**RE: REVIEW – ASSESSMENT REPORT FOR THE EVALUATION OF CONDITIONS IN THE REGIONAL AQUIFER  
AROUND WELL R-70  
LOS ALAMOS NATIONAL LABORATORY  
EPA ID#NM0890010515  
HWB-LANL-21-034**

**NMED TECHNICAL COMMENTS ON ASSESSMENT REPORT FOR THE EVALUATION OF  
CONDITIONS IN THE REGIONAL AQUIFER AROUND WELL R-70, JUNE 30, 2021**

#### **9. Figure 4.1-25 Approximate hydraulic zone of influence of pumping at R-70 S1 and S2, Page 56**

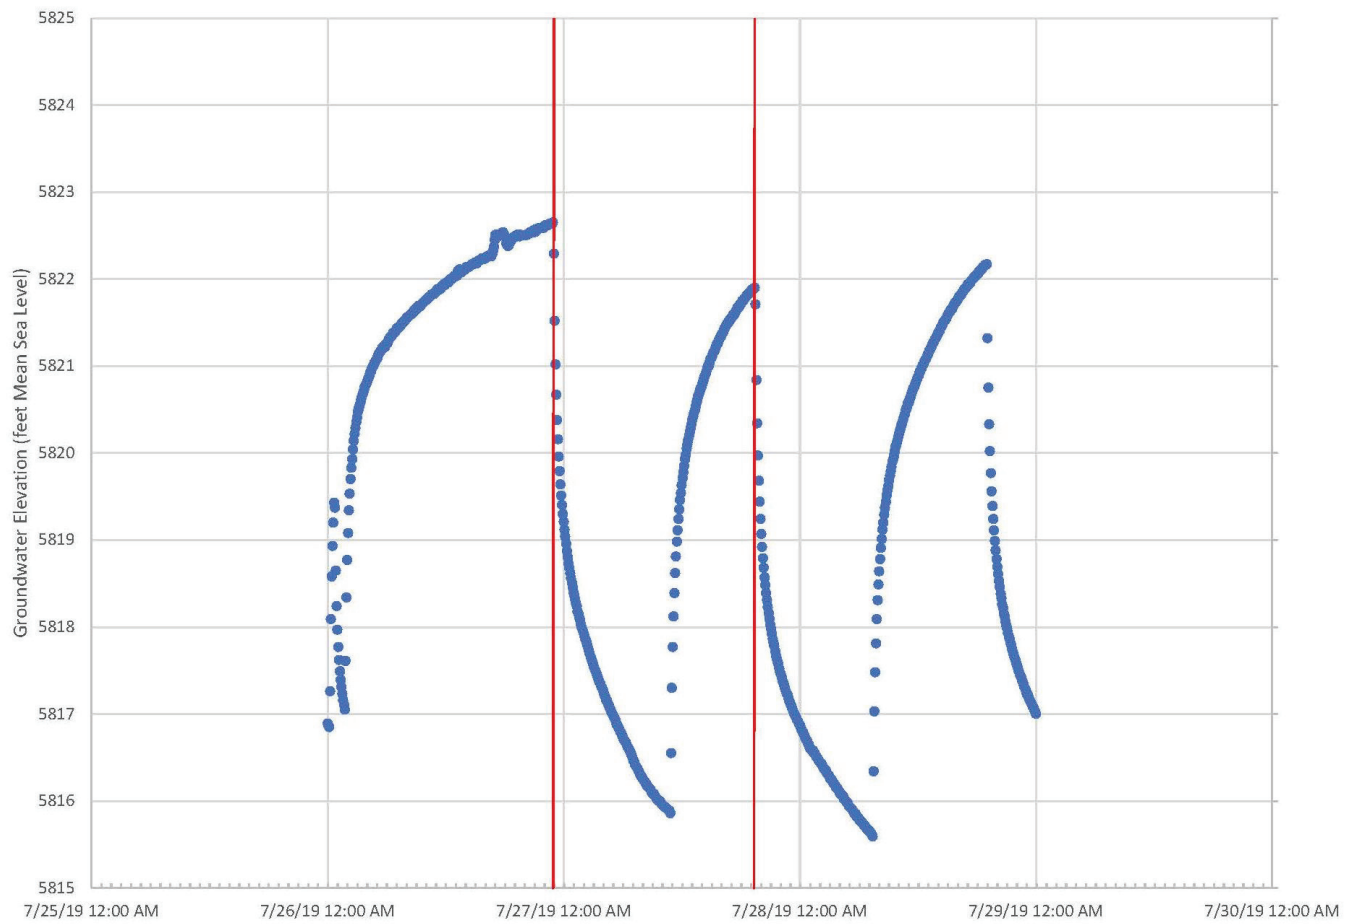
**NMED Comment:** In this figure, DOE shows an approximate hydraulic zone of influence from R-70 pumping as an elongated oval with the major axis trending north-south and the minor axis trending east-west. However, R-70 is not at the center of the oval but is offset to show that R-35a/b and PM-3 do not lie within the zone of influence of R-70 pumping. The issue is that CrIN-2 and R-44 do not respond to the R-70 pumping as shown in Figures 4.1-21 and 4.1-22, respectively, but are inexplicably included within the zone of influence depicted in Figure 4.1-25. NMED notes that if the perimeter of the zone of influence depicted by the oval was correctly shifted east to exclude R-44 and CrIN-2 as it should, R-35a/b would be closer to R-70's zone of influence.

Review of this figure with the conceptual model postulated in Section 2.4 (that preferential pathways would

follow interconnected beds of high hydraulic conductivity that cross formational contacts), a case can be made that preferential pathways exist as fingers or sinuous pathways along these beds between R-70 S2 and PM-3. In this scenario, DOE has made the case for installation of R-35c considering that it has been demonstrated that R-13 may be hydraulically connected to R-70 whereas CrIN-2 and R-44, which are closer to R-70 than R-13, are apparently not hydraulically connected. Additionally, R-70 S2 is not in the same strata as either R-35a or R-35b. A potential sinuous preferential pathway, whether along the base of the Puye or not, may exist between these two points in high hydraulic conductivity Tcar. This is a valid assessment as the vertical extent of the chromium concentration is unknown at R-70 and PM-3 pumping of the high transmissive Tcar (see Specific Comment 5) is likely to pull water in all directions within the Tcar to the well including R-70.

# Aquifer Parameters Between PM-3 and R-35a

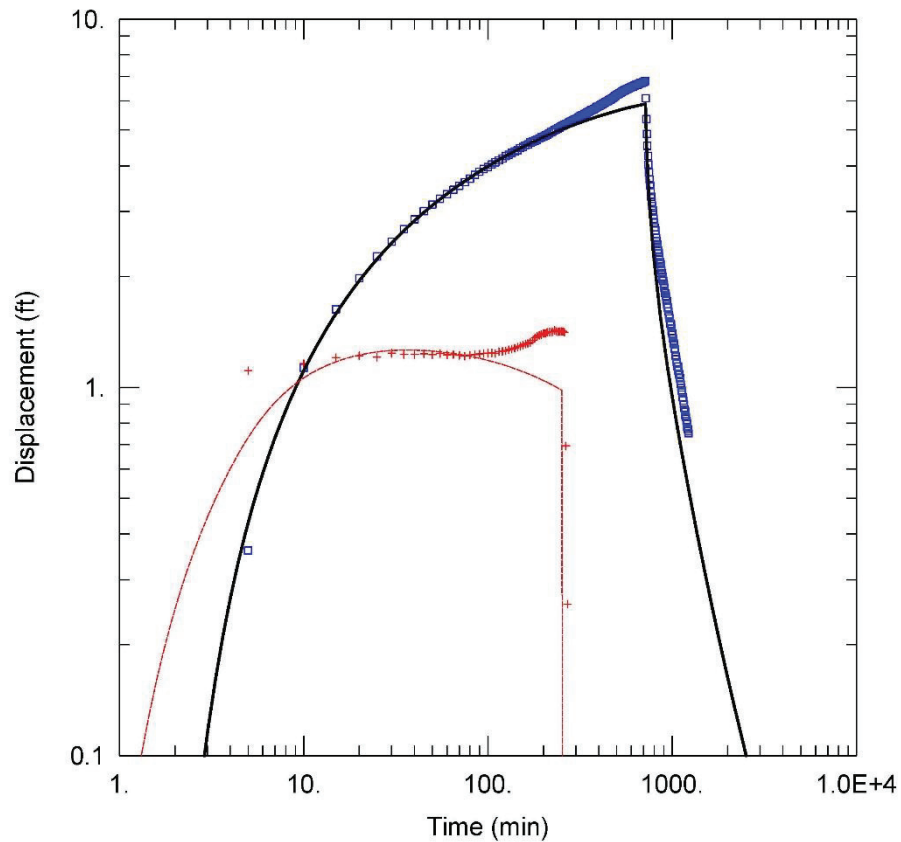
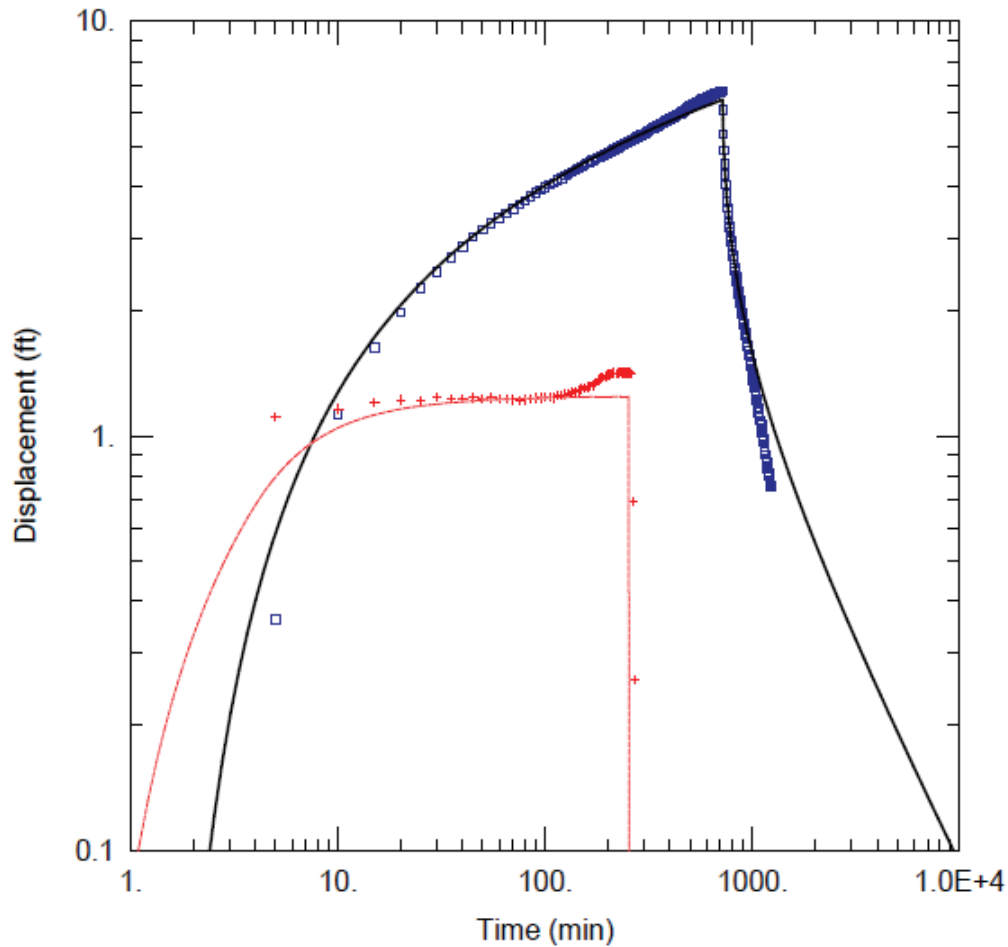
NMED’s analyses was performed using HydroSOLVE, Inc.’s AQTESOLV Professional version 4.5 aquifer test analysis software and is provided in Attachment 1 to Exhibit 1. NMED has determined that the aquifer transmissivity of the Tcar is about 18,500 square feet per day, a storativity of 0.0015 and hydraulic conductivity of 78 feet per day when modeled as an unconfined system. NMED also considered a confined model due to the lack of a similar hydraulic response at R-35b, certain unconfined solution parameter limits being reached during convergence of the unconfined model, and a potential localized unsaturated/confining layer at a depth of 929 feet at PM-3. In the confined analysis, NMED used a thickness of 176 feet (thickness of Tcar between 929-foot anomaly and the top of the Miocene basalt) to derive appropriate aquifer parameters. The confined model analysis resulted in a transmissivity of 17,500 square feet per day, a storativity of 0.0009, and a hydraulic conductivity of 99 feet per day for the Tcar portion of the regional aquifer, which is more than an order of magnitude greater than the analysis shown in Figures 2.2-1 through 2.3-3 of the Report.
